Subject: Duke Energy Carolinas, LLC (Duke Energy)
Catawba Nuclear Station, Units 1 and 2, Docket Nos. 50-413, 50-414
McGuire Nuclear Station, Units 1 and 2, Docket Nos. 50-369, 50-370
Response to Request for Additional Information – 10 CFR 50.46 30-Day Report
Regarding Thermal Conductivity Degradation in the Westinghouse-Furnished
Realistic Emergency Core Cooling System Evaluation

**Response to NRC Requests for Additional Information (Questions 1a, 1c, and 1d)
(Westinghouse Non-Proprietary)**

Catawba Unit 1 & 2 and McGuire Unit 1 & 2 – Response to NRC Formal Request for Additional Information (RAI) from the Reactor Systems Branch Related to the 10 CFR 50.46, 30-Day Report

**Response to NRC Requests for Additional Information (Question 2)
(Duke Energy Non-Proprietary)**

Figure 1

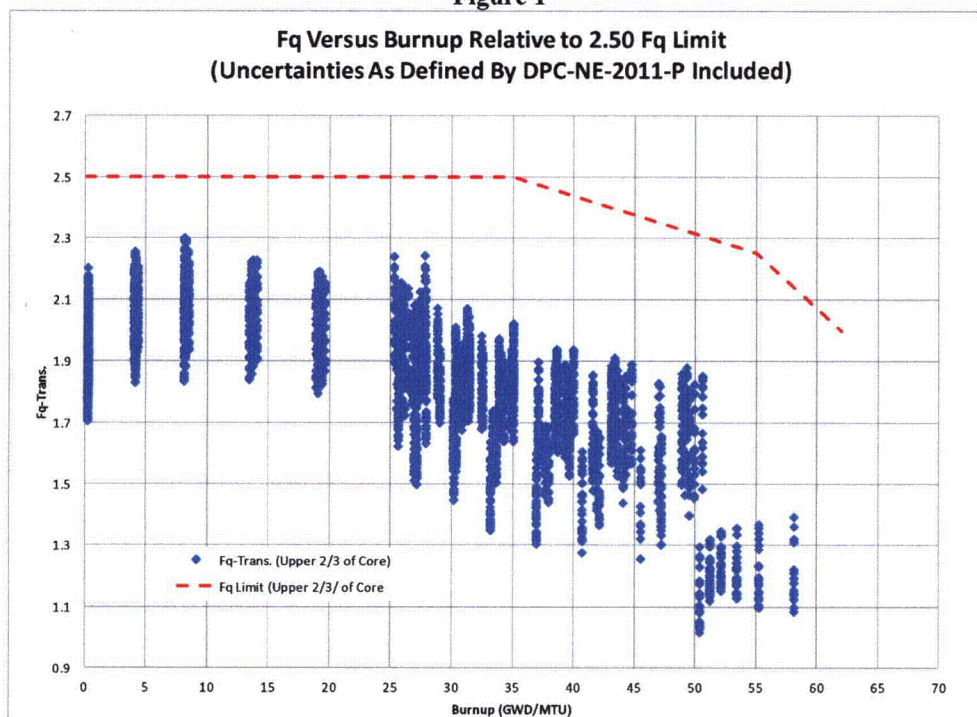
2. Please explain how the changed design values will be verified during operation of the plant, i.e. TS limits, Surveillances, etc. Also, explain what compensatory actions will be taken if a value is found to be outside of the limits assumed in the analysis.

Results from cycle-specific analyses show the revised BE-LBLOCA limits that account for TCD do not change the limiting peaking margins or the core locations of the limiting peaking margins. Core locations with minimum peaking margin occur in fuel with burnups less than 30 GWD/MTU, which is well before the effect of TCD becomes important. This important conclusion demonstrates that the decrease in fuel reactivity with increasing burnup is significant enough to limit the power producing capability of high burnup fuel to a level that more than offsets the effect of the peaking factor burn down needed to account for the effects of TCD shown in Table 1. Figures 1 and 2 show F_Q transient peaking factors as function of burnup calculated for a typical core design. These factors represent the calculated maximum F_Q that can occur during normal operation and from operational transients as constrained by axial flux difference and rod insertion limits specified in the Core Operating Limits Report. Because McGuire and Catawba have an axial dependent F_Q limit, 2.5 for the upper two-thirds of the core and 2.7 for the lower one-third of the core, the F_Q transient peaking is shown in two plots (Figures 1 and 2). The peaking factor results presented in Figures 1 and 2 illustrate the significant burn down of the F_Q peaking factor at burnups greater than 30 GWD/MTU and the increase in margin relative to the limit at these higher burnups. $F_{\Delta H}$ and PBAR follow the same general trend as the F_Q trend shown in Figures 1 and 2.

Figure 3 shows best estimate steady state F_Q peaking factors at full power conditions compared against the revised transient F_Q limits. The best estimate steady state results represent the most likely condition for core peaking and illustrate the most likely margin to transient F_Q limit. The difference in margin between the best estimate steady state and transient plots is significant, and is a combination of the effects of adverse xenon distribution, control rod insertion and application of calculational uncertainty factors.
